Site Design for a Hotel on Pantops, Charlottesville

A Technical Report submitted to the Department of Civil & Environmental Engineering

The Site Design for a Hotel on Pantops, Charlottesville Final Report

TD-34

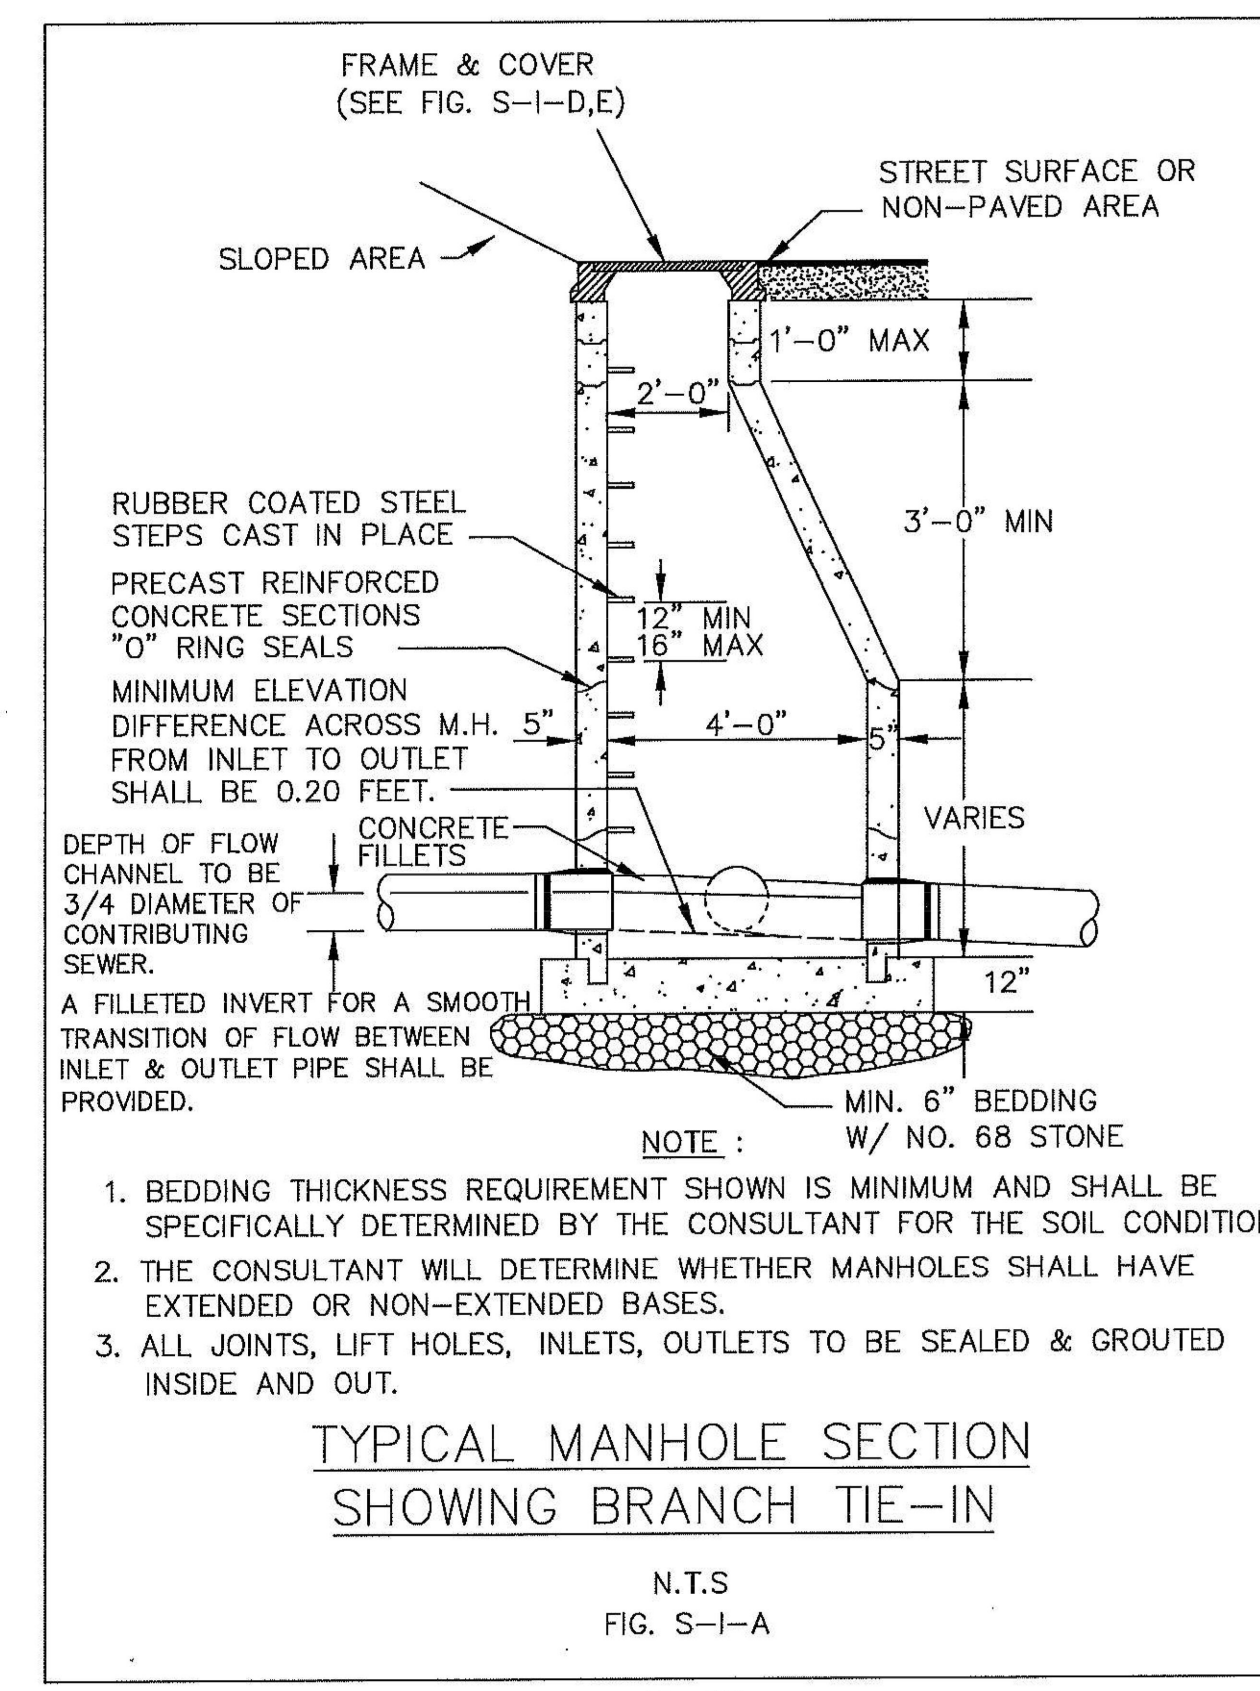
Add ACSA General Water &
Sewer Conditions located
on the Albemarle County
Service Authority website

JOB NO.	
SHEET NO.	2.2

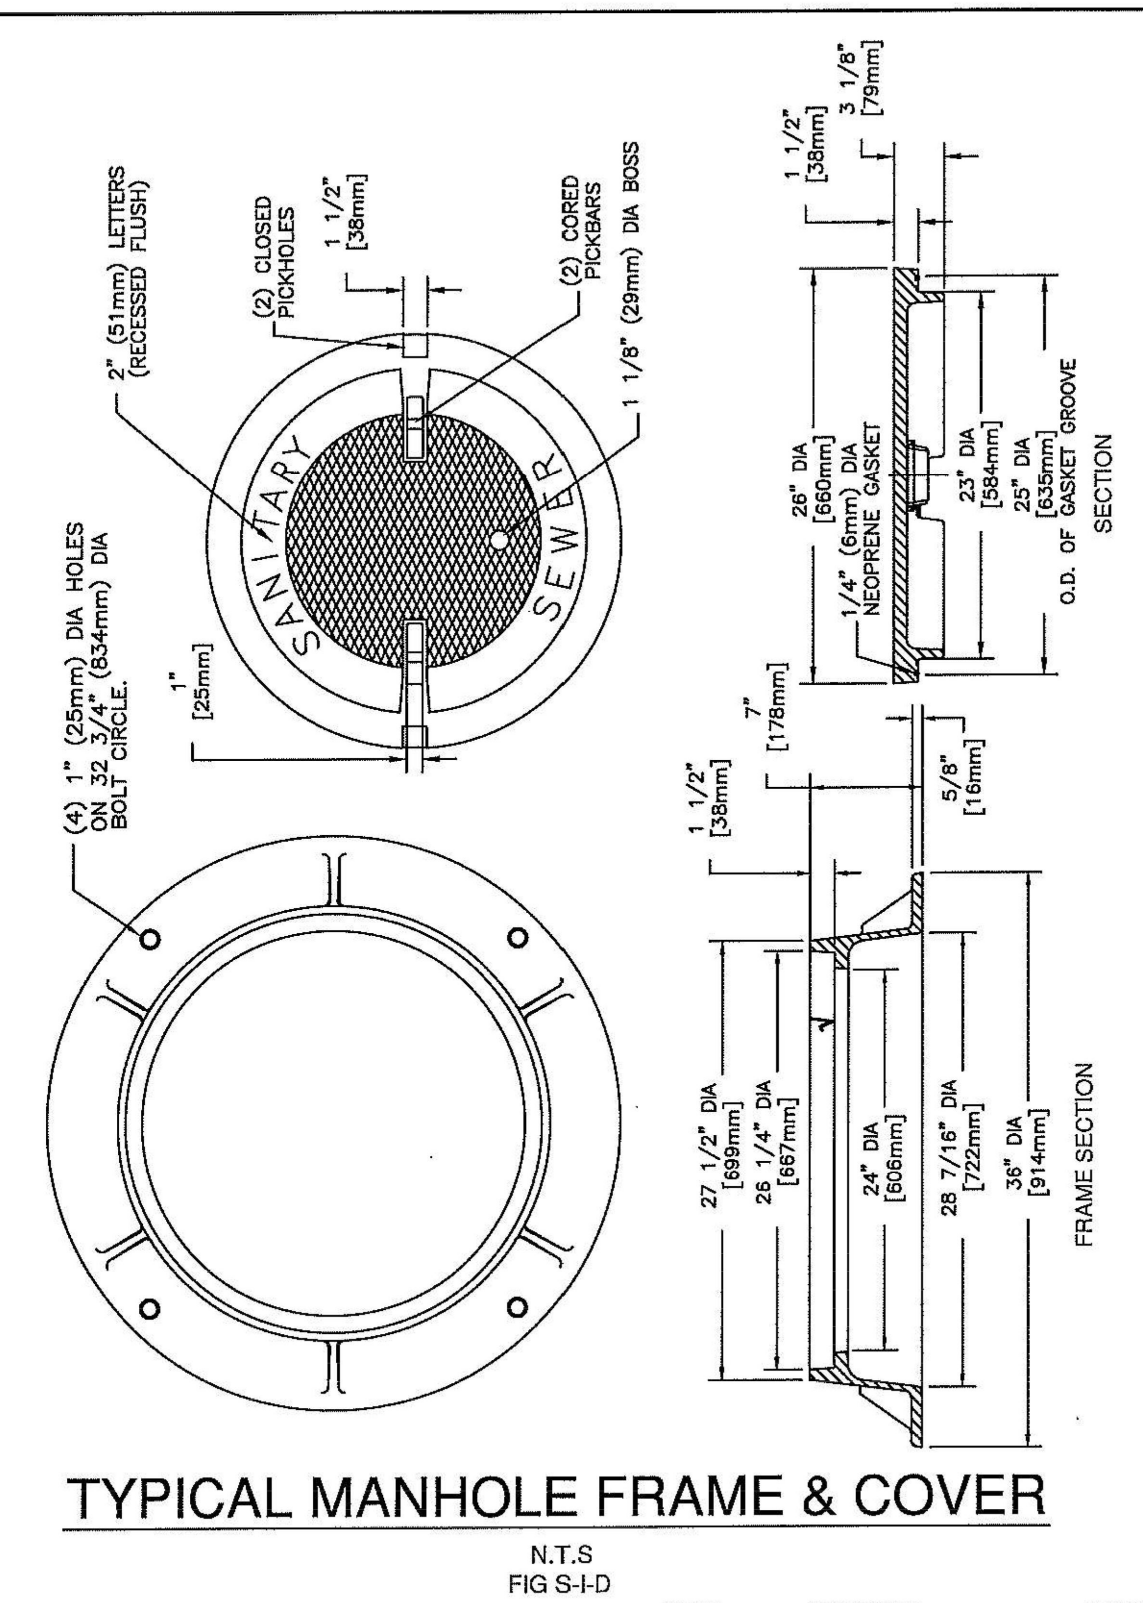
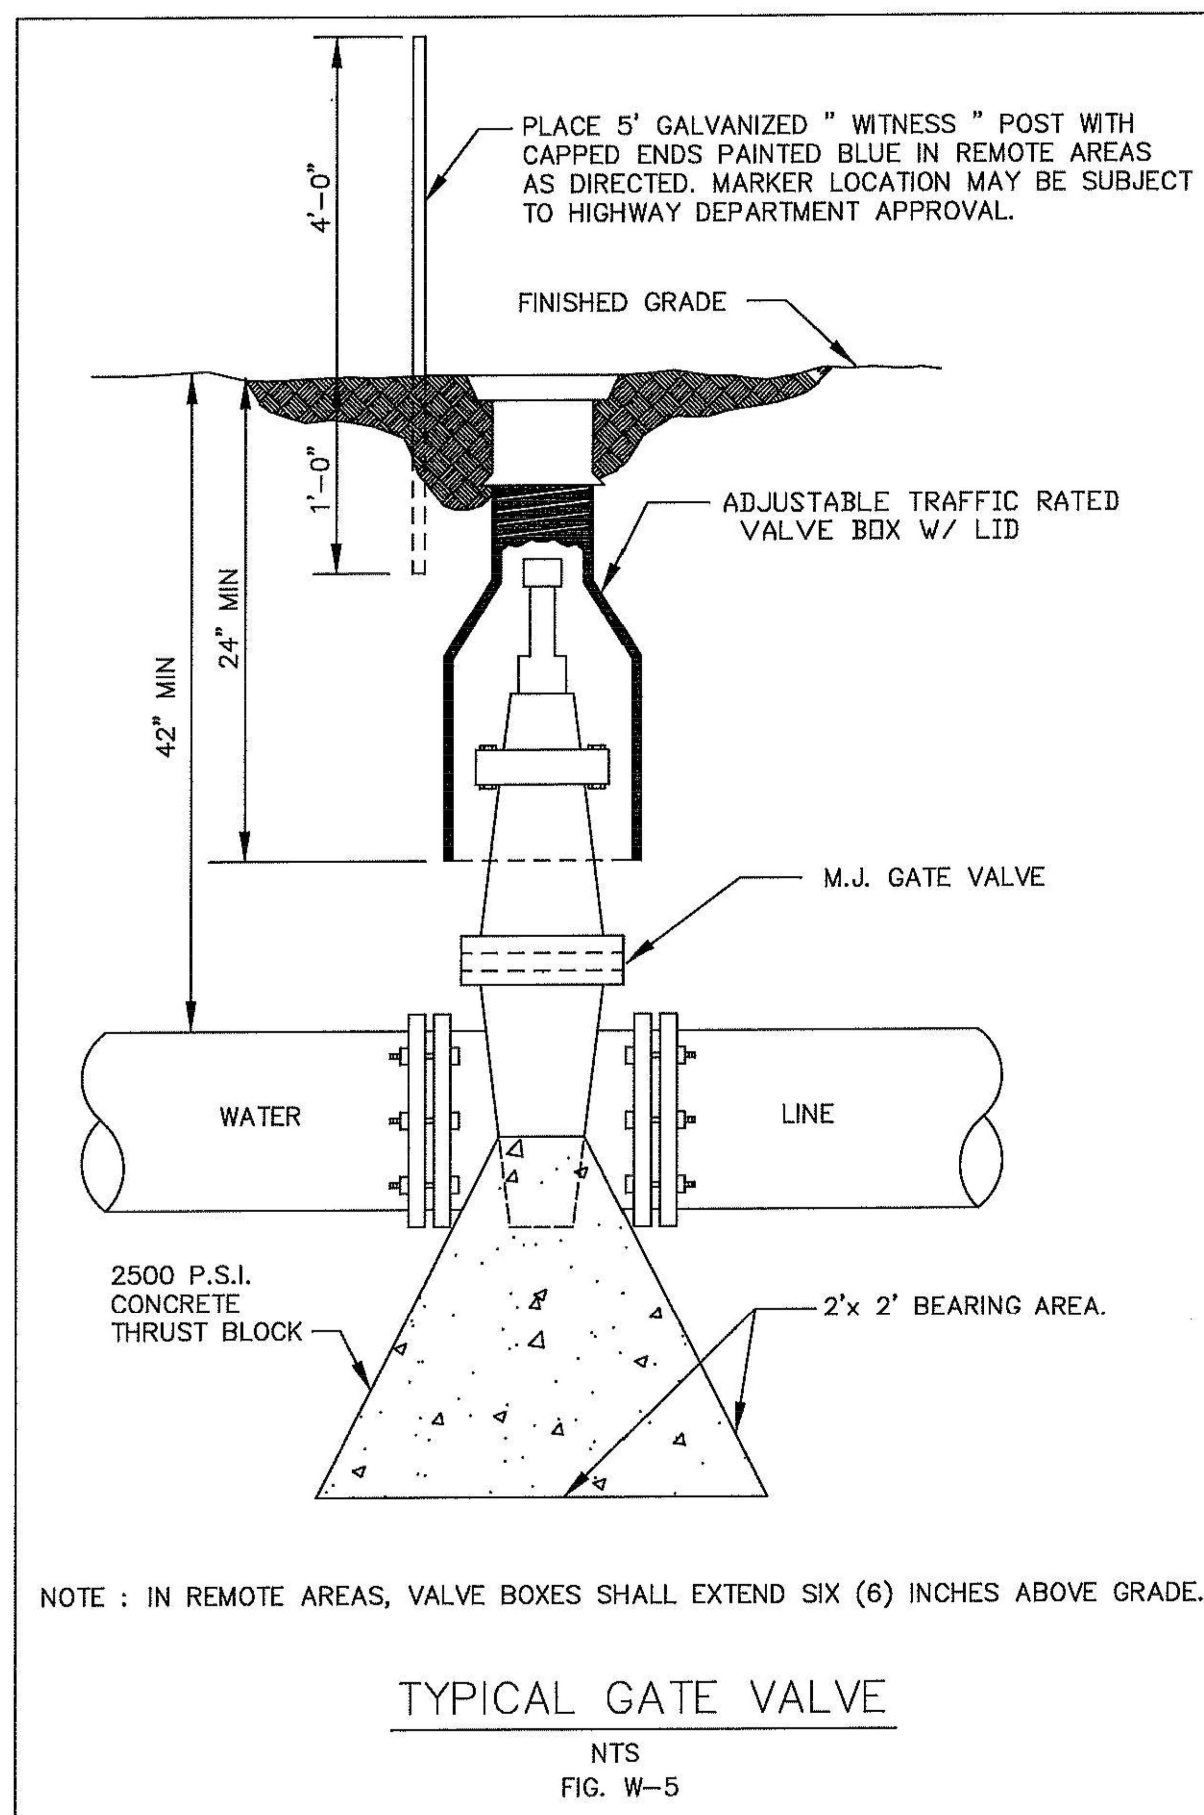
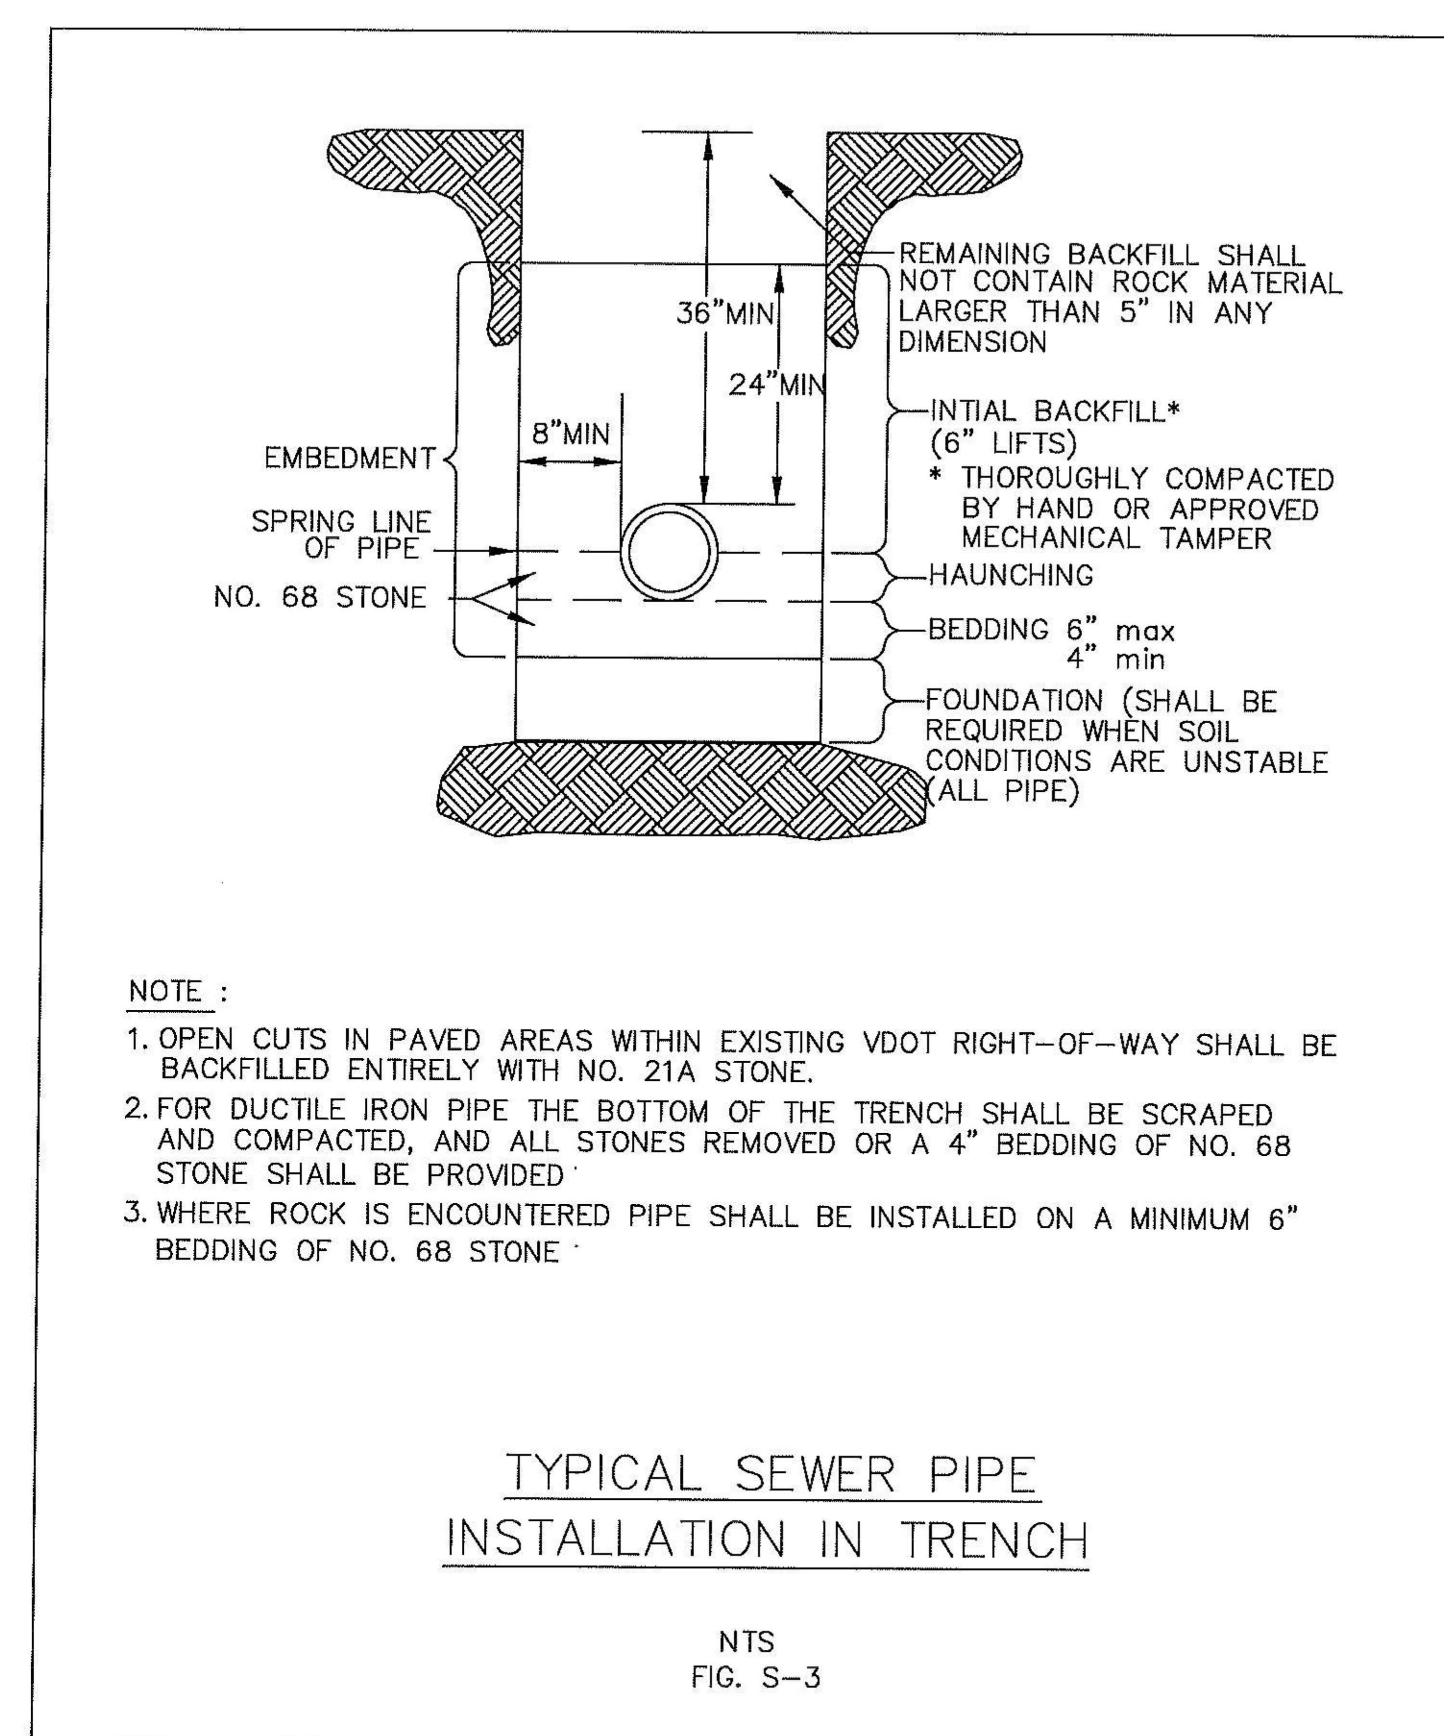
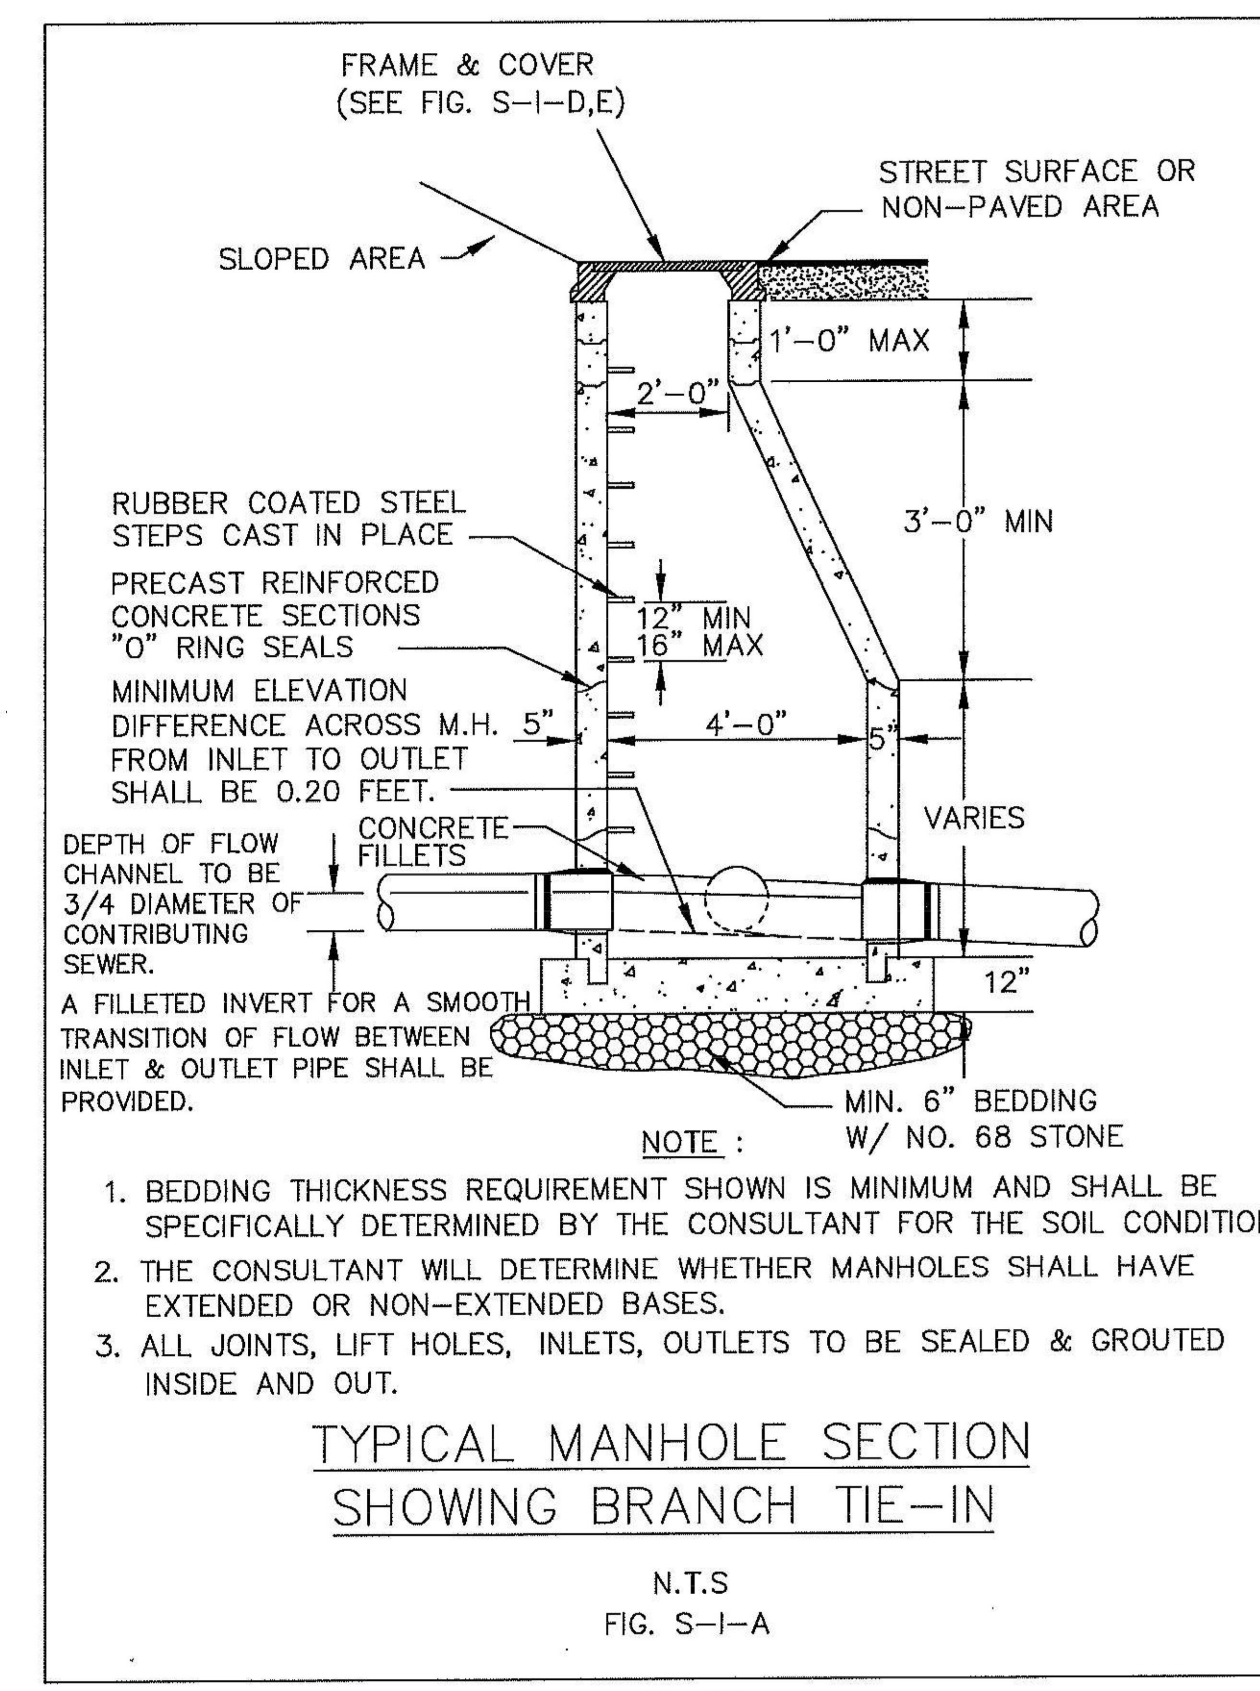
parking striping detail

ada sign detail

water meter detail
